## Directorate of Power Reactor Regulation

### **Subject: Darlington and Pickering NGS – Measurement and Prediction Methodologies of Hydrogen Equivalent Concentration**

**Attachment (1):** An Update on Measurements & Predictions of [H<sub>eq</sub>] Since June 2016

### An Update on Measurements & Predictions of [Heq] Since June 2016

Figure 5: Difference in UB Predictions between the 2018 and 2017 Bruce Power Units 5-7 Models [54]

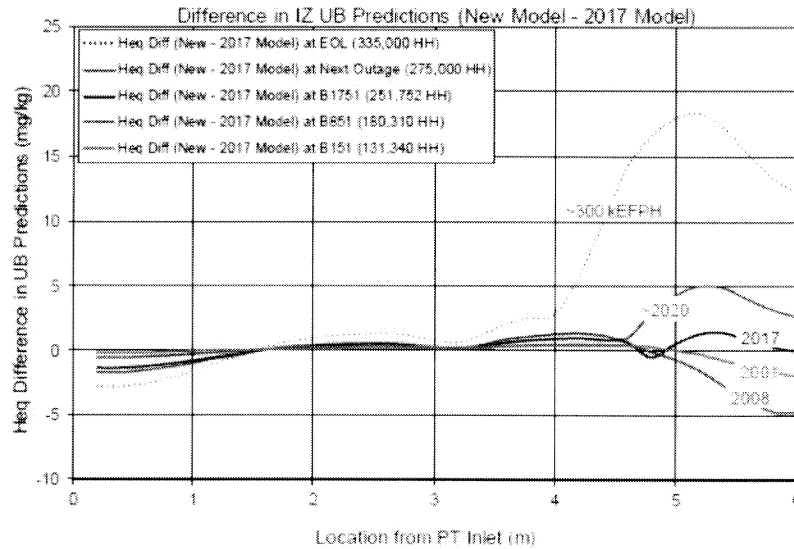
Overall, updates to the models can have profound effects on the  $[H_{eq}]$  predictions and, in turn, on various FFS assessments. For instance, the difference in the UB of the 2018 and 2017 Bruce Power Units 5-7 model is provided in Figure 5 below and taken from [54]. Without an overall and consistent approach to modelling BoT [D] data, including elements of mechanistic understanding,  $[H_{eq}]$  long-term predictions at the BoT are challenged, with potential ramifications for EoL projections and pertinent FFS assessments. Although new COG R&D programs for understanding and inclusion of mechanistic effects is welcome [52], it has been introduced late in the operation of many Units. Consequently, the development of new models capable to provide confidence for the long-term predictions and overall operation of the pressure tubes is of great interest to the CNSC.
